Report on submissions and further submissions on the
Proposed Waikato District Plan

Hearing 27D: Coastal Hazards

Response to Submissions on Waikato District Plan Stage 2: Coastal Hazard Area Maps (March 2021). Prepared by Bronwen Gibberd 4D Environmental Ltd and Jim Dahm Eco Nomos Ltd

**Response to Submissions on Waikato
District Plan Stage 2:
Coastal Hazard Area Maps**

Figure 2: Properties 209-215 Maunsell Road, Port Waikato.

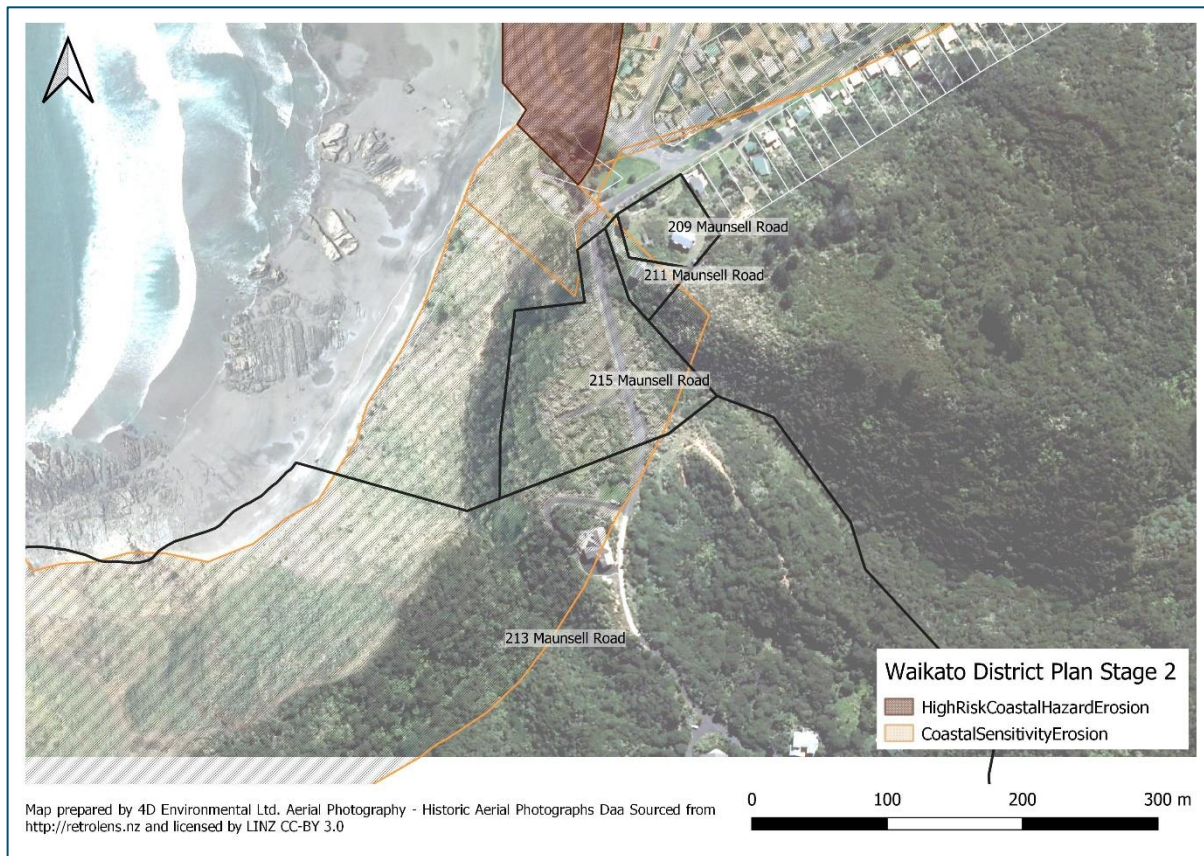
Submission: That the proposed Coastal Sensitivity Area (Erosion) be removed from several properties at the western (seaward) end of Maunsell Road (Figure 2). These submissions request removal or amendment of the erosion hazard areas that overlay the properties between 209 and 215 Maunsell Road.

Figure 5: Proposed adjustment to Coastal Sensitivity Area (Open Coast) at Maunsell Road, Port Waikato.

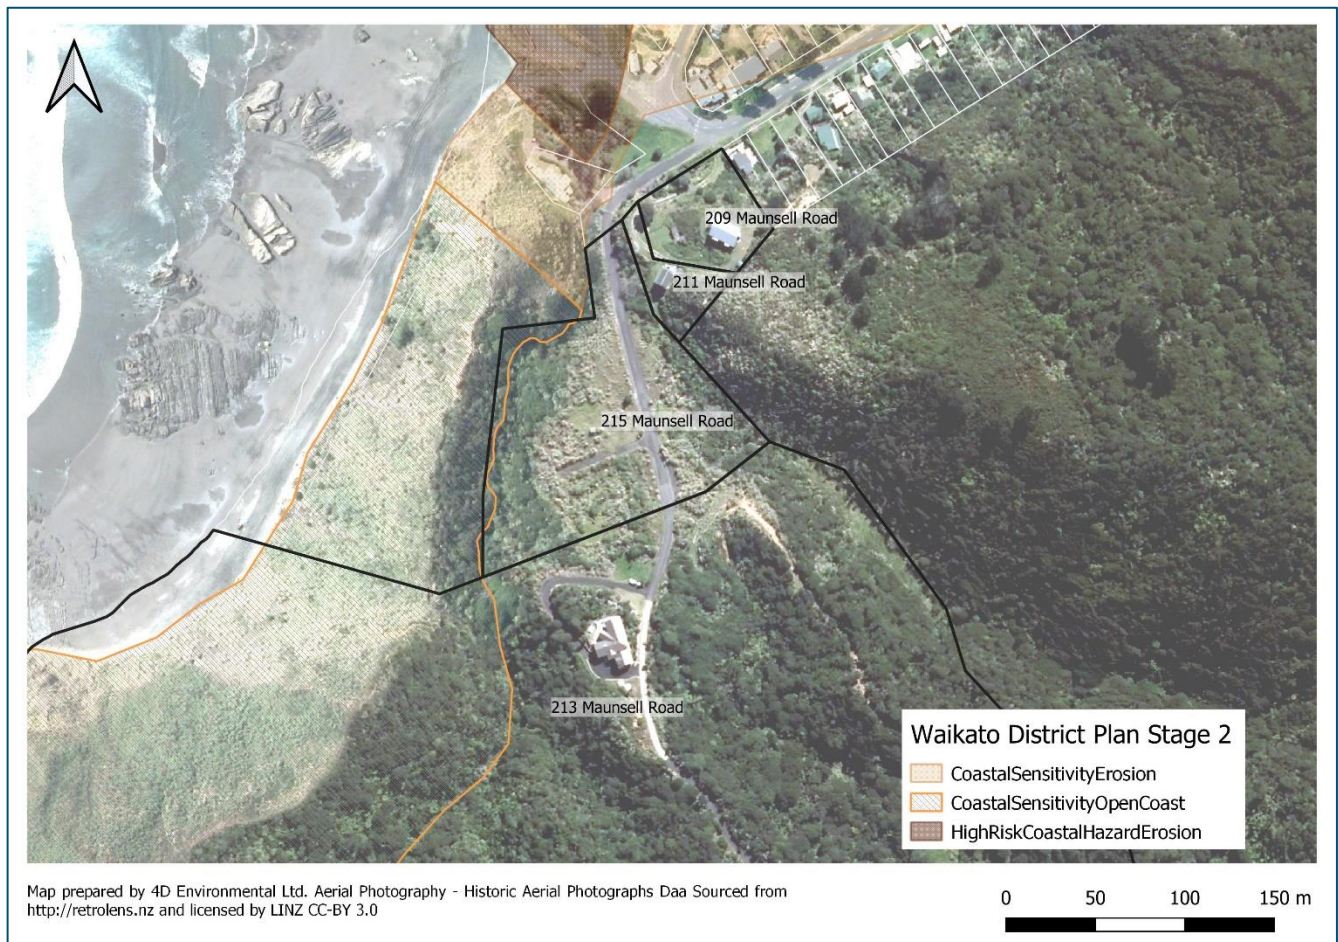
The historical shoreline change data indicates that the shoreline is considerably less dynamic than the sand spit further north and has fluctuated by up to 30 m since the 1940s. Historical photographs show that the area is sometimes fronted by a narrow sand dune, which erodes and rebuilds over natural decadal cycles. Most of the shoreline change observed in the area since the 1940s is associated with erosion and rebuilding of this sand dune. Harder materials to landward are periodically exposed and there is some geomorphic indications of past erosion and land sliding of the steep face, but there is little evidence of significant ongoing erosion over the available historical record (1940s onwards). A more detailed study would be required to accurately determine past erosion rates and slope stability to determine the extent of this seaward ridge likely to be vulnerable to coastal erosion in the next 100 years. It is, however, reasonable to assume that this ridge will remain in some form for the foreseeable future. The properties in question are well landward of any coastal erosion hazard.

Recommendation: We have recommended an adjusted Coastal Sensitivity Area (Open Coast) for this area that is defined by the back of the coastal ridge. The landward edge of the adjusted hazard area follows the stream valley (Figure 5). More detailed investigations (including field inspections) would be necessary to refine this

Figure 6: Location of submissions landward of Tuakau Bridge Road, Port Waikato showing the overlay of the proposed Coastal Sensitivity Inundation and Erosion.

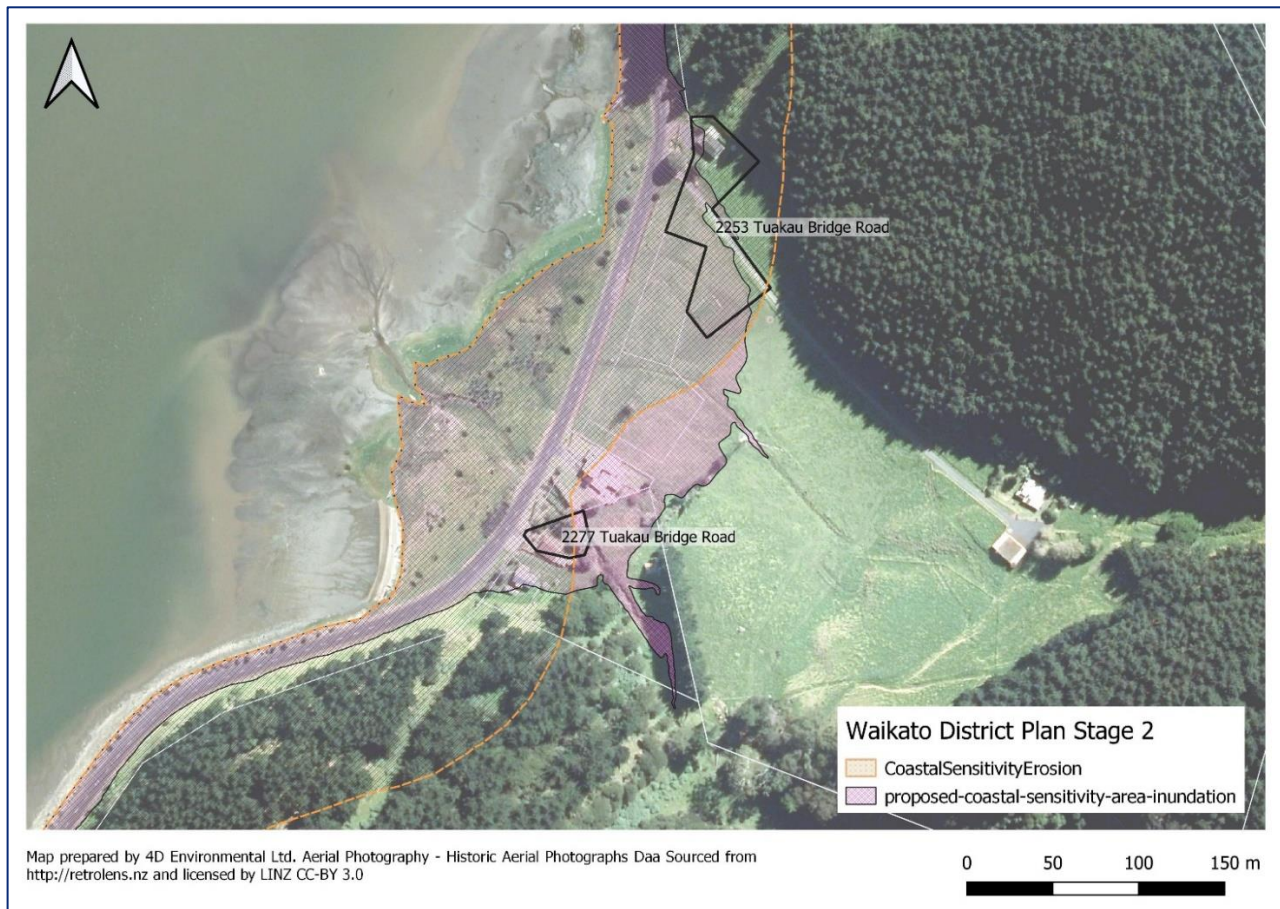
Submission: That the proposed Coastal Sensitivity Area (Erosion) and Coastal Sensitivity Area (Inundation) be removed from properties at Tuakau Bridge Road, Port Waikato (2253 and 2277 Tuakau Bridge Road). The two properties are landward of Tuakau Bridge Road, approximately 2 km upstream (east) of the Port Waikato Township (Figure 6). These submissions have requested the removal of the sensitivity areas on the basis that the properties and dwellings are some distance from the river bank, and there has been no historic flooding or erosion in the area.

The Coastal Sensitivity Area (Erosion) is 100 m wide on rural estuarine shorelines. The properties in question here are landward of Tuakau Bridge Road, and 50-100 m from the bank of the Waikato River. The submitters here feel that this is over conservative and that the properties in question are unlikely to be impacted by coastal erosion even with sea level rise.

We suggest that if the Council is committed to retaining Tuakau Bridge Road as key access to Port Waikato, the Coastal Sensitivity Area (Erosion) could be limited to the landward side of Tuakau Bridge Road as shown in Figure 7.

Figure 8: Notified Coastal Sensitivity Area (Erosion) and recommended High Risk Coastal Hazard Area (Erosion) and Coastal Sensitivity Area (Erosion) at Te Akau South.

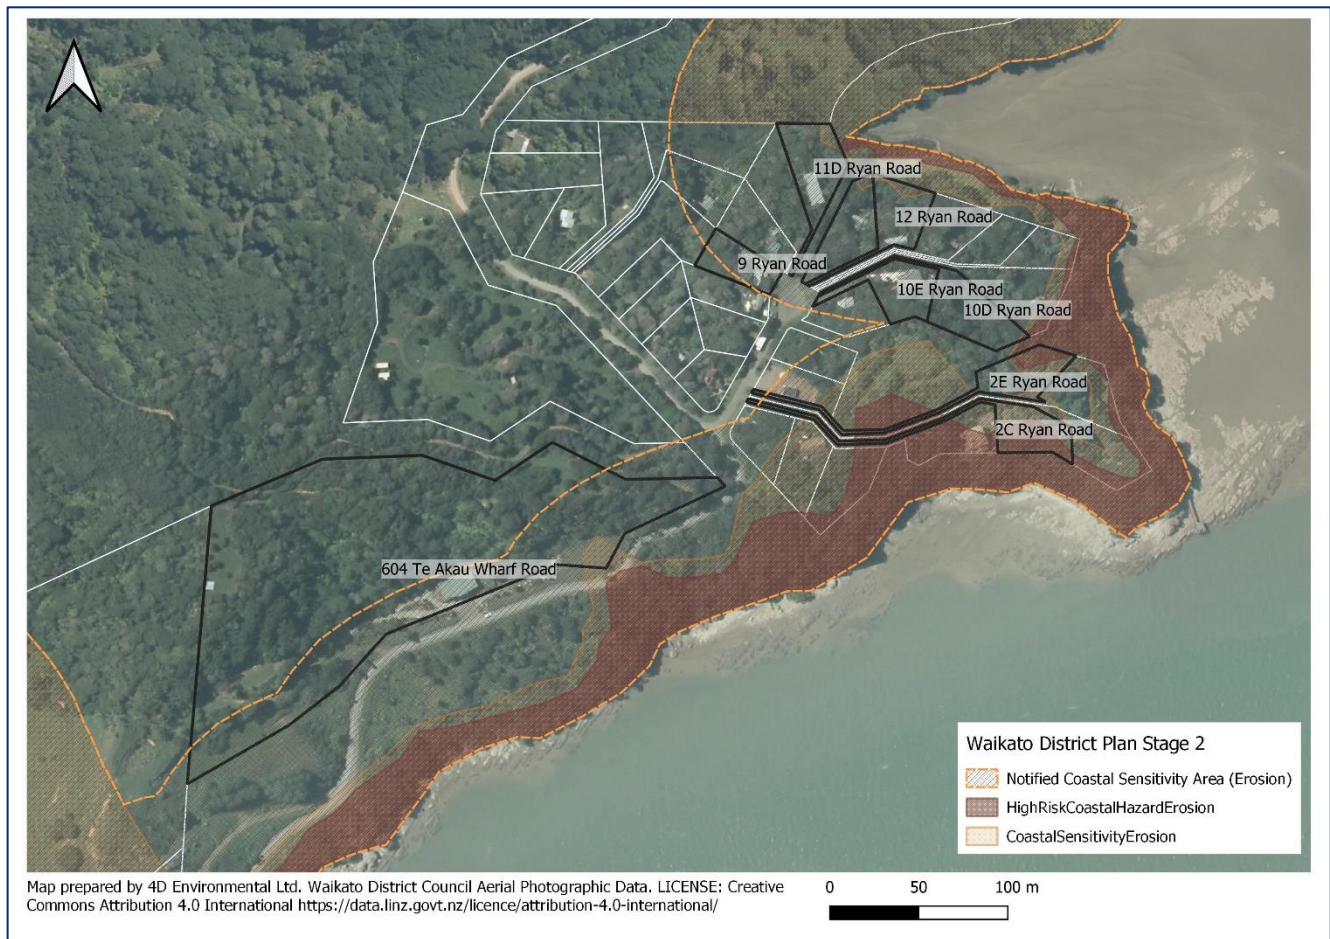
This coastal hazard assessment has identified criteria for the definition of a High Risk Coastal Hazard Area (Erosion) and Coastal Sensitivity Area (Erosion) on the coastal margin of Te Akau south, including 604 Te Akau Wharf Road, and the Village zone area on the Horongarara Peninsula. The revised coastal hazard and sensitivity areas vary in width depending on the geology, elevation and slope of the coastal margin from 20-60 m (High Risk Coastal Hazard) and 30-80 m (Coastal Sensitivity). The area is widest backing the high steep slopes at 2a and 2c Ryan Road and 585 Te Akau Wharf Road (Figure 8).

Figure 11: Cross shore profile at 27 Lily Street, illustrating steep elevated topography.

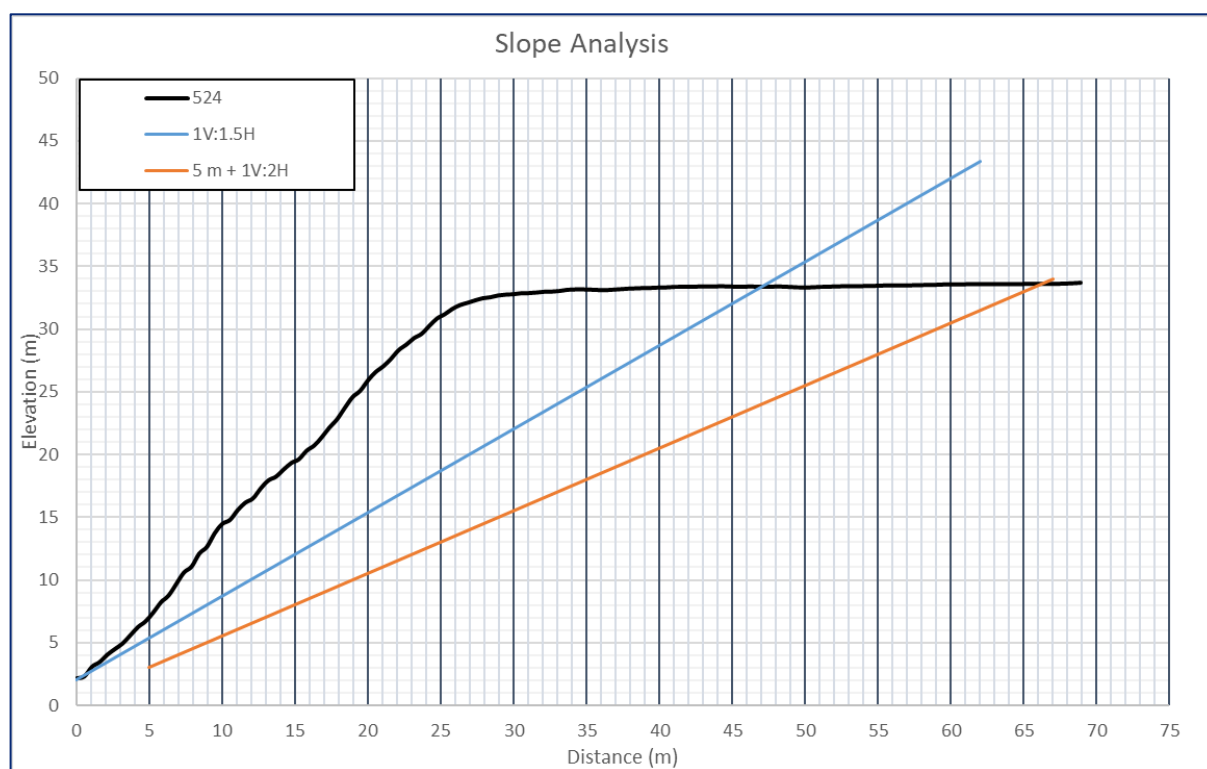
The properties at 27, 29 and 31 Lily Street are significantly affected by the High-Risk Coastal Hazard Area (Erosion) and Coastal Sensitivity Area (Erosion). The properties are fronted by a reserve to seaward and the existing dwellings are located more than 50 m from the shoreline at an elevation of 20-30 m above sea level. The properties at 27 and 29 Lily Street and 28 Government Road are relatively flat, but the reserve to seaward is steeply sloping (approximately 1V:1H) (Figure 11, Figure 12). The property at 31 Lily Street is sloping and fronted by a very steep coastal cliff, which is steeper than 1V:1H. The High Risk and Coastal Sensitivity Areas reflect the potential for failure of these very steep slopes.

We recommend that the High Risk Coastal Hazard Area (Erosion) be amended to reflect a steeper stable slope (1V:1.5H) (Figure 14 & Figure 15). This slope is consistent with observed failures in the area.

Figure 13: Cross section at location of recent land slip on Bay View Road. Elevation data represents pre-slip profile. Blue arrow indicates approximate location of landward slip edge.

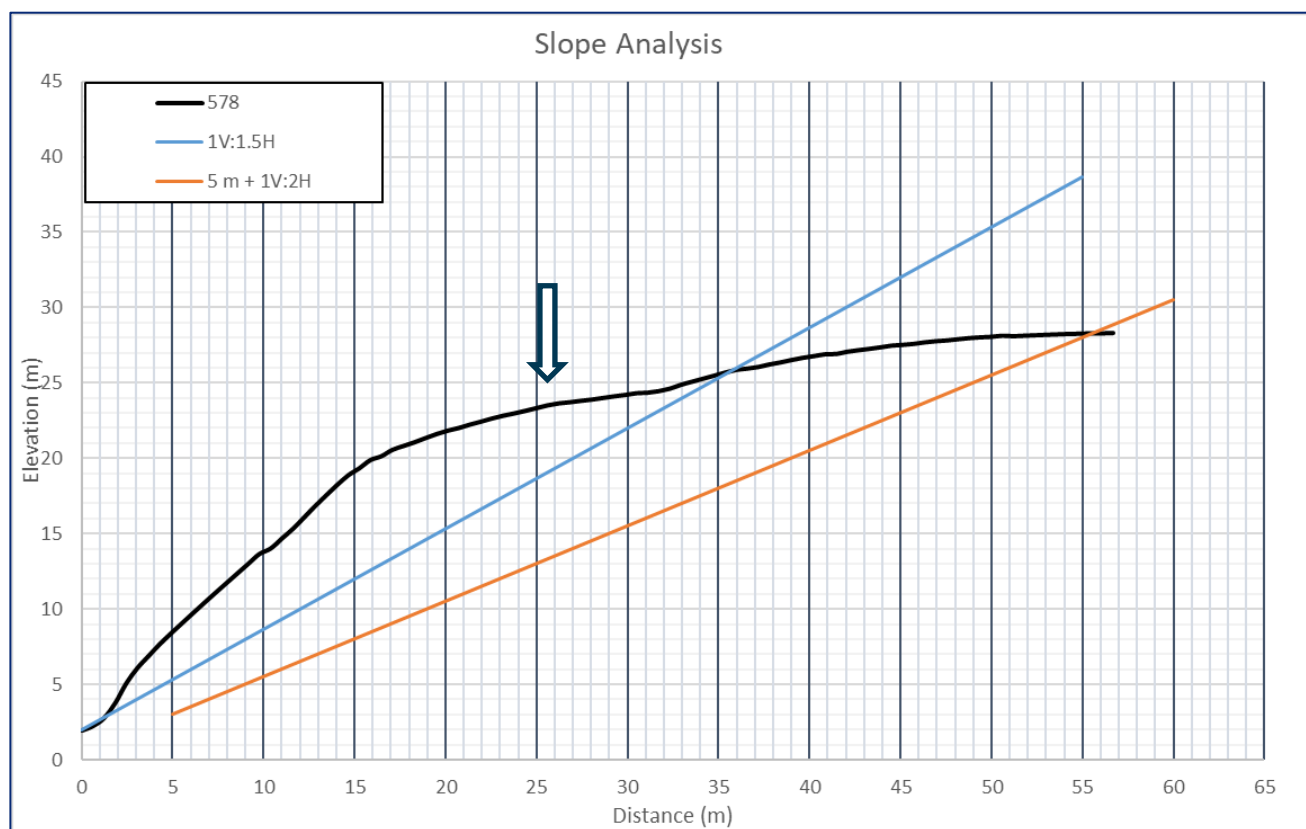
Two submissions have been received that relate to the High-Risk Coastal Hazard Area (Erosion) and Coastal Sensitivity Area (Erosion), which overlay significant portions of the properties at the seaward end of Bayview Road. 31 and 39 Bayview Road are both deep, elevated properties (>20 m elevation) northwest of Lorenzen Bay. Both properties are fronted by high coastal cliffs with slopes of approximately 1V:1H.

Site visits were undertaken at 31 and 39 Bay View Road, to gather further site-specific information and a field inspection was also completed to gather up to date information about the state of the shoreline and existing instability. During a site visit to 31 Bay View Road, observations were made of the top edge of a recent landslide on the neighbouring property. This provided useful insight into the potential failure slopes in the area. Based on the location of the landward edge of the land slide allowed an estimation of the gradient of the slip (Figure 13). These measurements and other observations of local cliff slopes suggests that most failures are within a 1V:1H – 1V:1.5H slope. Accordingly, we believe that the High Risk Coastal Hazard Area (Erosion) can be amended to reflect a steeper stable slope of 1V:1.5H.

Figure 15: Recommended refinement of High Risk Coastal Hazard Area (Erosion) at Daisy Street and Bay View Road. The darker shaded area indicates the refined high risk area.

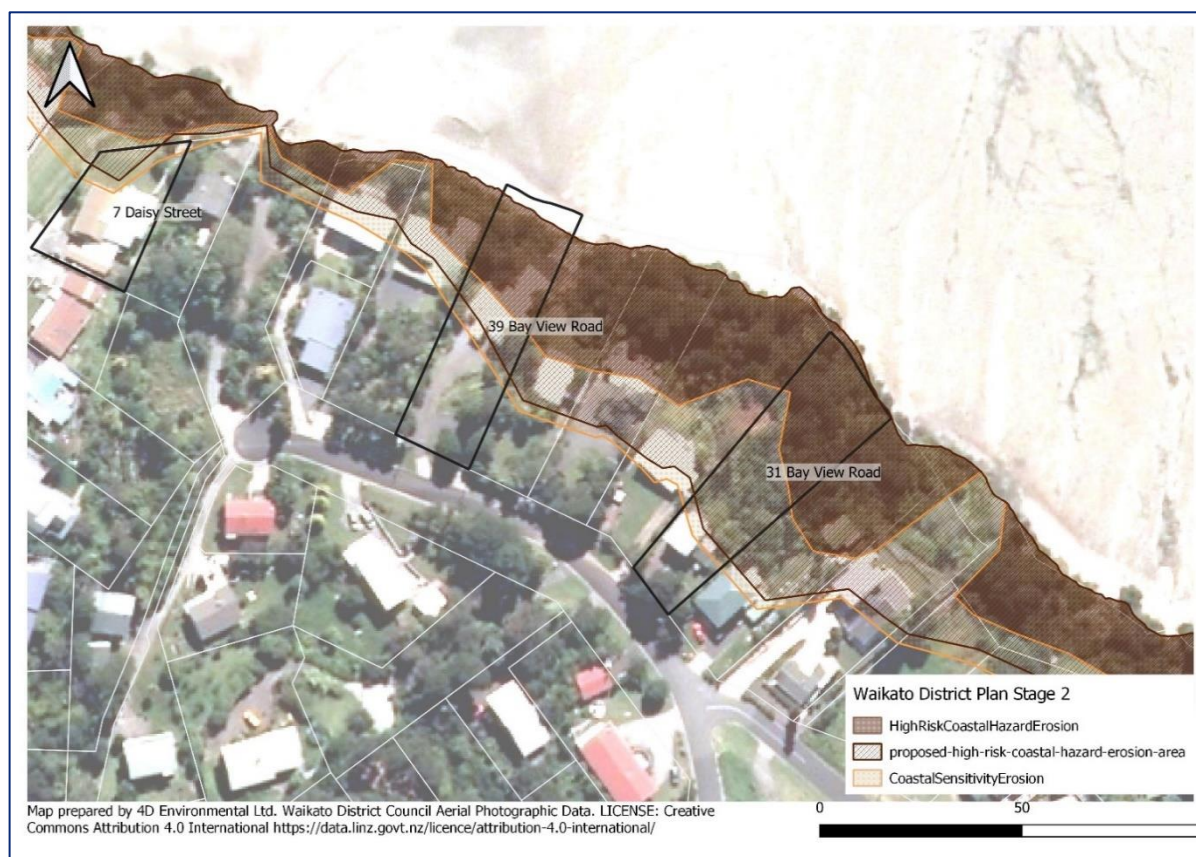
Number 7 Daisy Street is elevated, and the existing dwelling is located at approximately 12 m above sea level. The reserve to seaward of the property slopes steeply from the shore to 9-10 m elevation, at a slope of nearly 1V:1H. Further landward, slopes decrease to between 1V:1.5H and 1V:2H. The High-Risk Coastal Hazard Area (Erosion) and Coastal Sensitivity Area (Erosion) overlay the north eastern corner of the property, seaward of the dwelling. The eastern portion of the property has lower gradients, and therefore the hazard and sensitivity areas are reduced in width in this area (Figure 14).

Figure 17: Cross section through coastal reserve seaward of 104c Greenslade Road. Elevation data pre-dates slip event. Blue arrow marks the approximate location of top of slope failure.

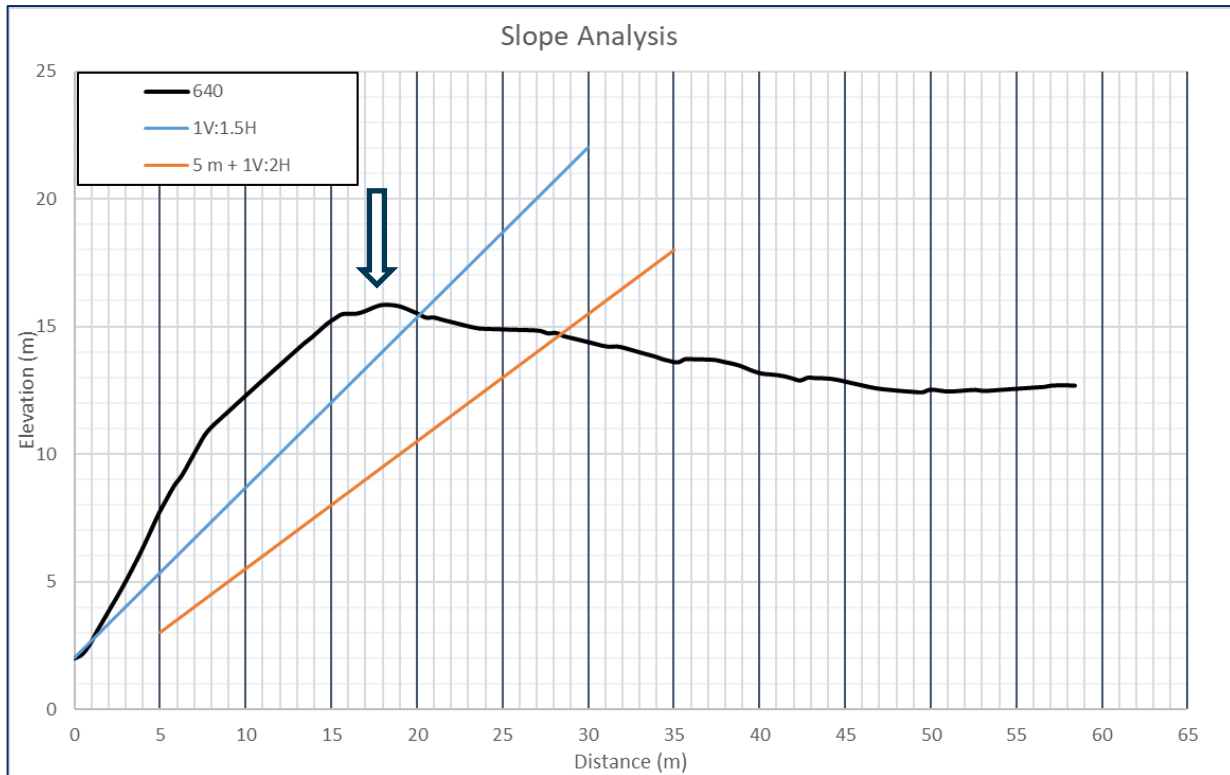
Further field observations were made, with particular attention to a relatively recent (July 2017) slope failure in the Council reserve fronting 104c Greenslade Road (Figure 16). Field measurements and analysis of the DEM data indicates that the slope of this failure is close to 1V:1.5H (Figure 17). This provided useful insight into the potential failure slopes in the area. It is possible that site specific investigations (combined with careful management) may confirm that steeper slopes can be maintained safely, at least in some areas. However, we do not have sufficient data to apply a steeper slope broadly across the area.

We recommend that the High Risk Coastal Hazard Area (Erosion) be amended to reflect a steeper stable slope (1V:1.5H) (shown in Figure 18). While most existing slopes are steeper than 1V:1.5H, this slope provides for failures such as that observed at 104c Greenslade Road. While ongoing management of the cliffs will help to prevent such failures, with current knowledge it is not possible to assume that such actions can limit all future failure to slopes of 1V:1H or steeper.
